COMMUNITY SERVICES DEPARTMENT

April 27, 2022

Subject: Rolling Hills Ranch North Early Grading and Erosion Control Plan Review (EGP-22-002)

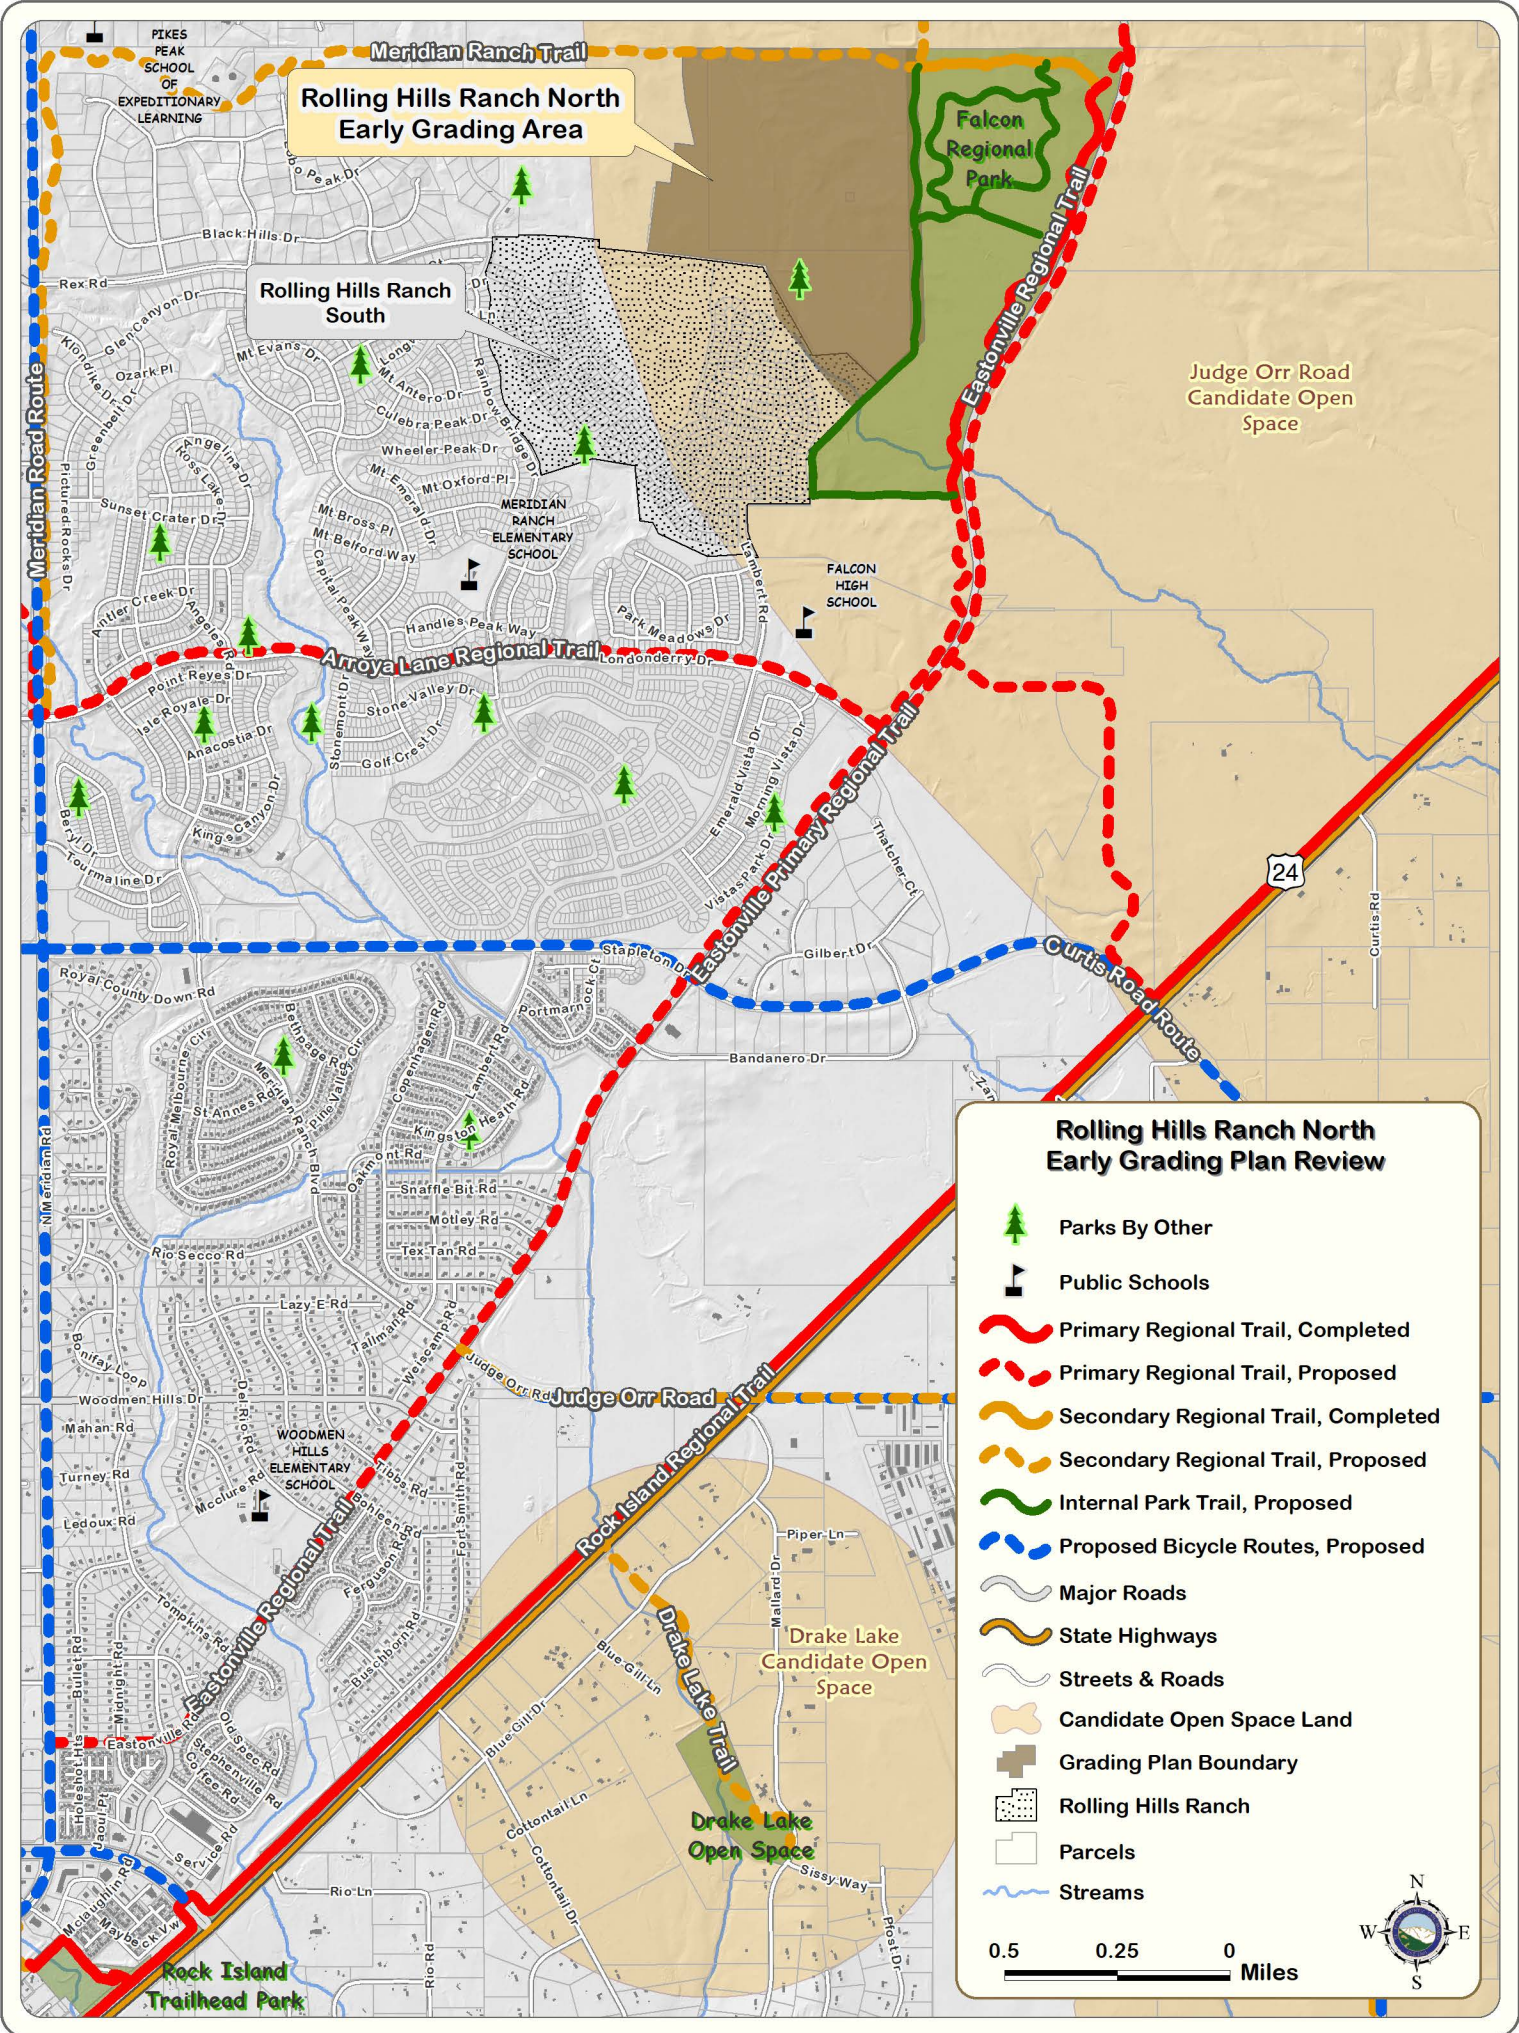
However, Sheets, 11, 13, and 14 of the Early Grading and Erosion Control Plans shows 25'-40' wide drainage channel being constructed along the northern boundary of the proposed residential lots of Rolling Hills Ranch North, within the bounds of 54-acre Hydrologic Element HG-13. This drainage facility channels overland runoff eastward then southward into an existing natural drainage channel in Falcon Regional Park. The plans do not show any stormwater detention facilities along the channel's path, and therefore it can be assumed that stormwater runoff will have a direct path into the natural drainage channel in Falcon Regional Park. This natural channel proceeds southeastward through the park's passive-use open space areas and will be routed under the proposed Rex Road extension, before exiting the park under Eastonville Road, east of the main parking area. Staff is concerned that this unimpeded drainage channel will allow for a higher discharge velocity and could greatly impact the natural drainage in the park, creating a higher risk for flooding and erosion in what has proven to be a sensitive environment that does not respond well to extreme stormwater runoff events. Staff requests the applicant demonstrate that flows from this drainage channel will not negatively impact the natural or recreational values of the park.

Furthermore, while the 40' Drainage and Grading Easement allows for the construction of drainage facilities within its bounds, the aforementioned drainage channel does extend beyond the easement boundary and into Falcon Regional Park by an estimated 50 feet. The proposed drainage channel should be removed from County Property and located on the applicant's property as there is no documented easement providing for infrastructure within the park outside of the already provided drainage and grading easement.

Staff strongly recommends that the applicant work closely with El Paso County Parks to address these issues and find amicable solutions for the design and functionality of the HG-13 drainage channel.
